**From:** Maïc Tanguy  
**Sent:** 25/05/2025 10:08:53 PM  
**To:** DA Submission Mailbox  
**Subject:** Re: Submission Acknowledgment - RE: DA2025/0132 - 37 Roseberry Street  
BALGOWLAH NSW 2093

**RE: DA2025/0132 - 37 Roseberry Street BALGOWLAH NSW 2093**

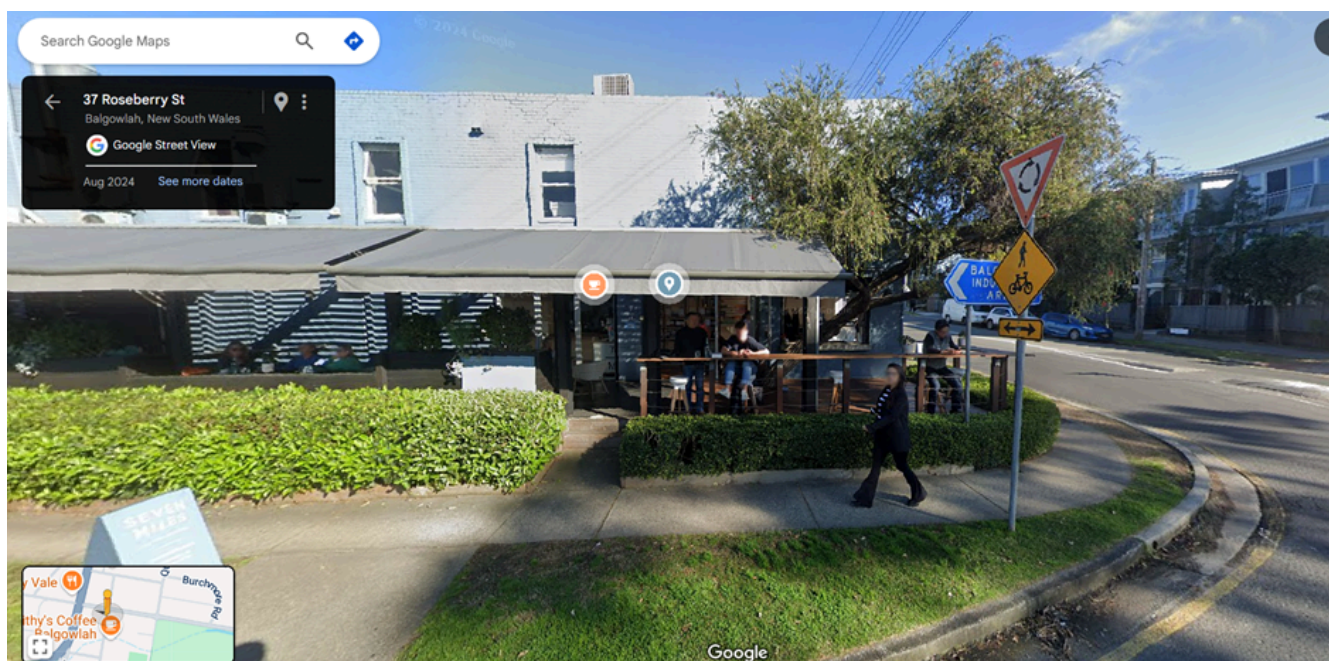
Thanks for giving the opportunity to comment on the proposal. I object the proposal. A drive-through McDonald doesn't seem to be the best development for this site for the following reason:

- This type of development and urban form (with parking and drive through lanes) doesn't seem to be strategically compatible with the low to medium rise housing reform which encourages increased density and sustainable development in Manly Vale. It goes backward compared to the existing development. It is also a missed opportunity for a mixed development combining ground floor retail with potentially light industrial and/or apartments, if that is allowed by the zoning.

- The fast food outlet, together with the proposed drive through and parking, will encourage significant amount of car traffic, compared to another type of development (see trips generation rates from guide to TIA for comparison). This will impact both the liveability of the area, the safety of people walking and cycling, and the congestion at nearby intersections.
